102-07981-MLL/MDD
October 18, 2019

Subject: **Palo Verde Nuclear Generating Station (PVNGS) Units 1, 2, and 3 and Independent Spent Fuel Storage Installation (ISFSI) Docket Nos. STN 50-528, 50-529, 50-530 and 72-44 Renewed Operating License Nos. NPF-41, NPF-51, NPF-74 License Amendment Request for Changes to Emergency Plan Staffing Requirements**

License Amendment Request Changes to Emergency Plan Staffing Requirements

FIGURE 1 ONSHIFT EMERGENCY ORGANIZATION

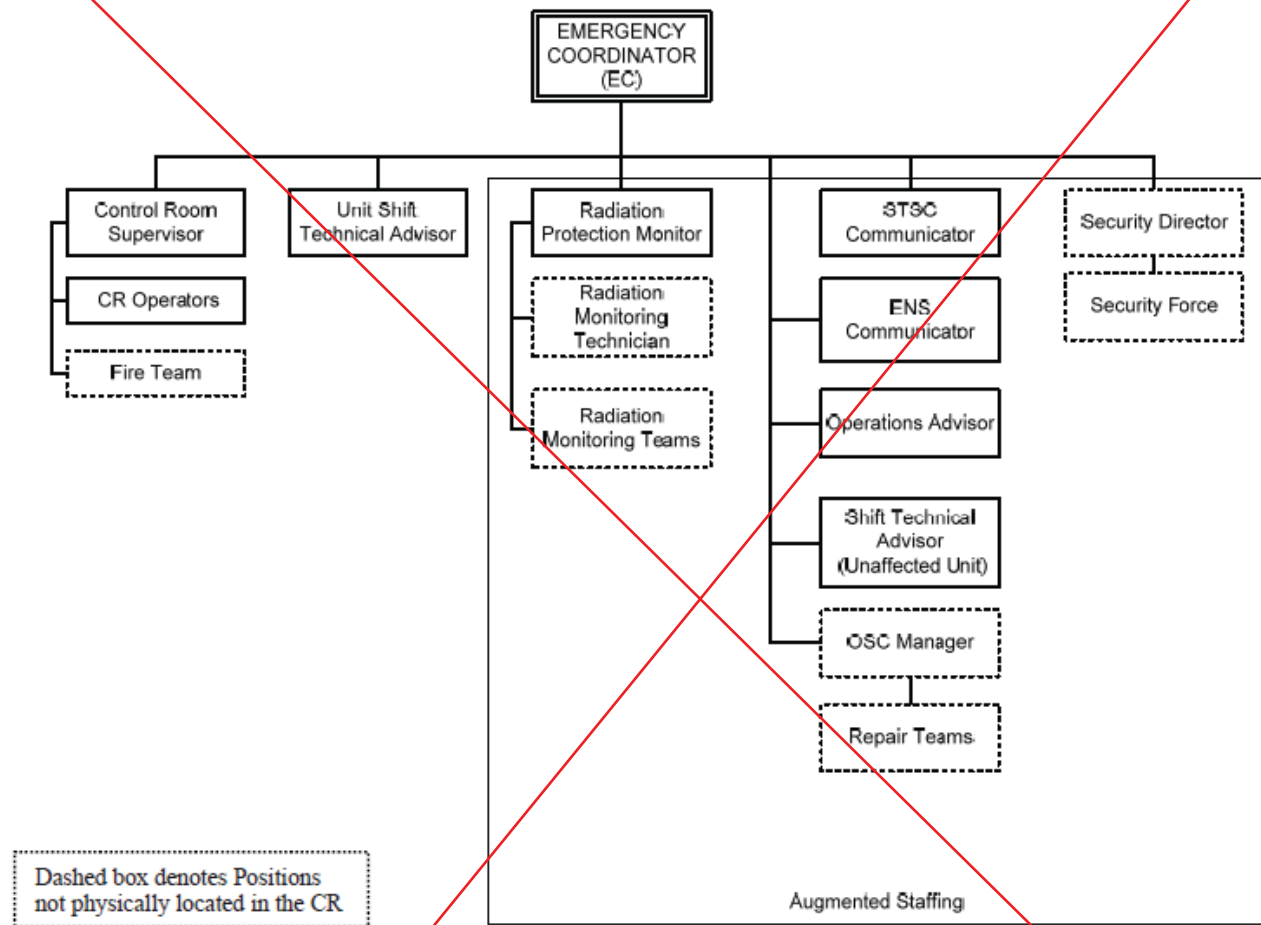
~~The On-shift Emergency Organization (Figure 1) consists of the following positions:~~

The On-shift Emergency Organization (Figure 1) consists of the following positions:

FIGURE 2 TECHNICAL SUPPORT CENTER ORGANIZATION

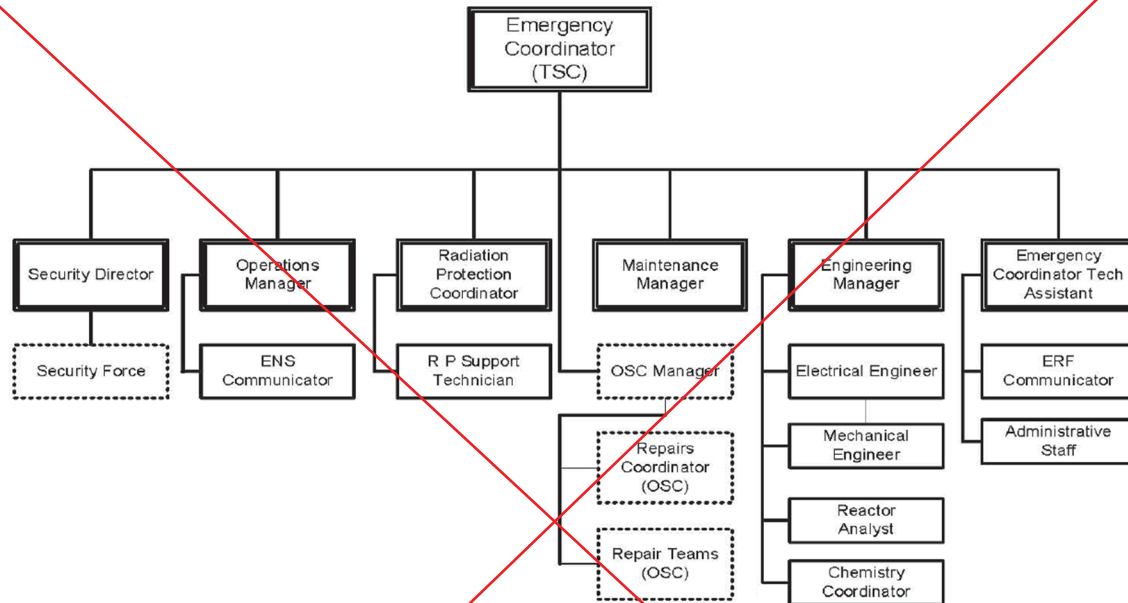
~~The TSC Organization (Figure 2) is located on-site and consists of the following positions.~~

The Augmented Emergency Response Organization that staffs the Technical Support Center (Figure 2) consists of the following positions:

FIGURE 3 OPERATIONS SUPPORT CENTER ORGANIZATION

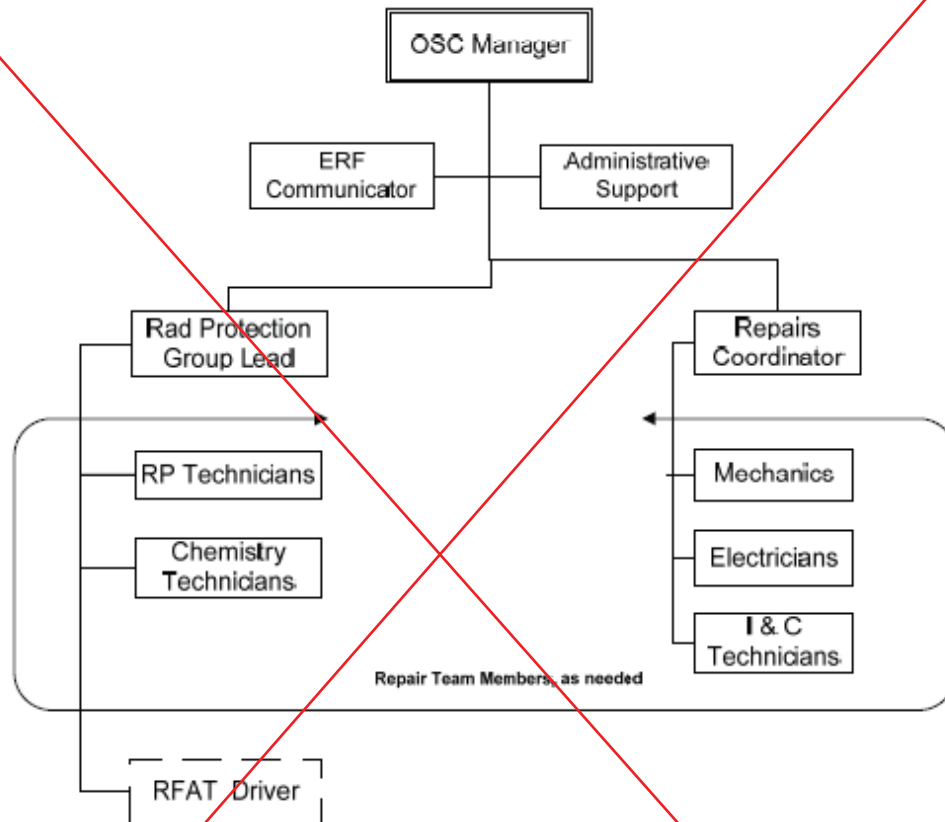
~~The OSC Organization (Figure 3) is located onsite and consists of the following positions.~~

FIGURE 4 EMERGENCY OPERATIONS FACILITY ORGANIZATION

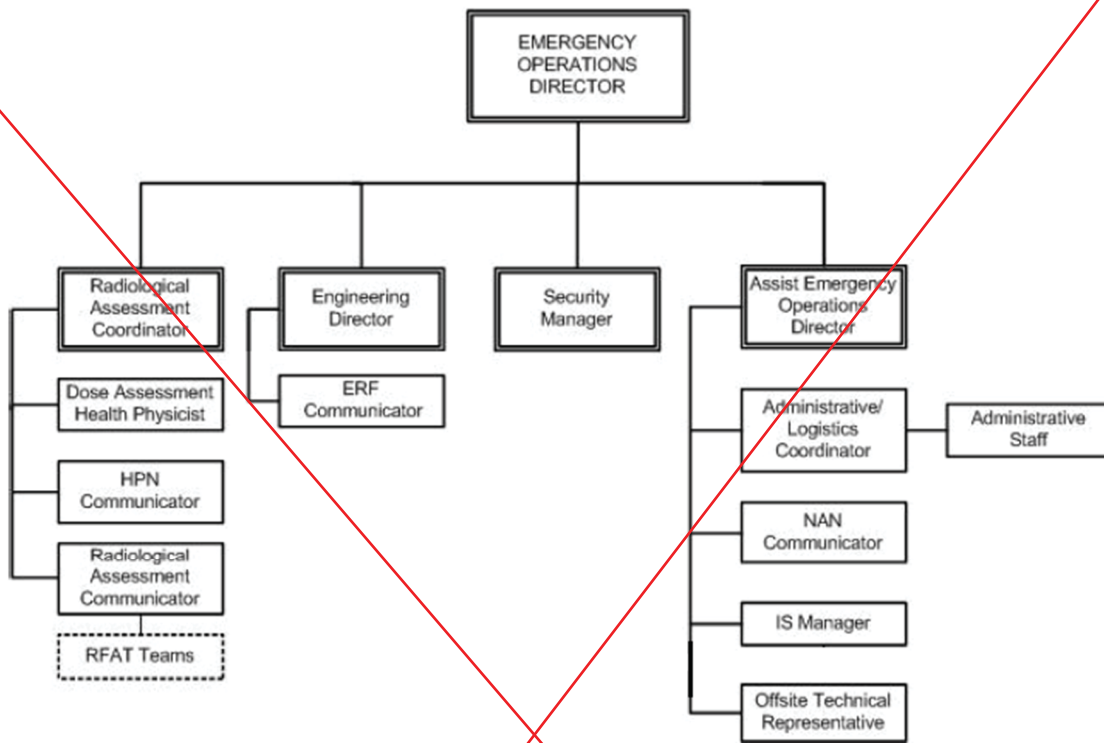
~~The EOF Emergency Organization is illustrated in Figure 4. The interfaces between the Onsite and Offsite Emergency Organizations are shown in Figure 6.~~

FIGURE 5 JOINT INFORMATION CENTER ORGANIZATION

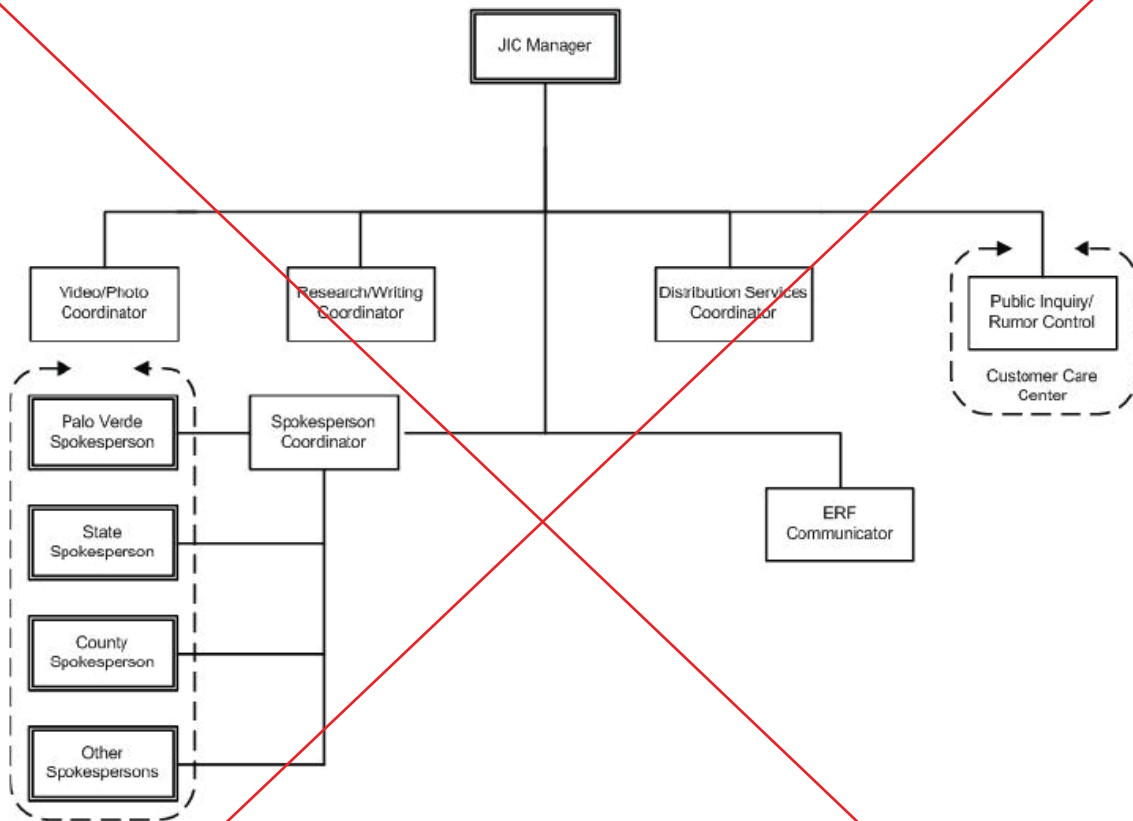
~~The JIC Organization (Figure 5) is located offsite and consists of the following positions.~~
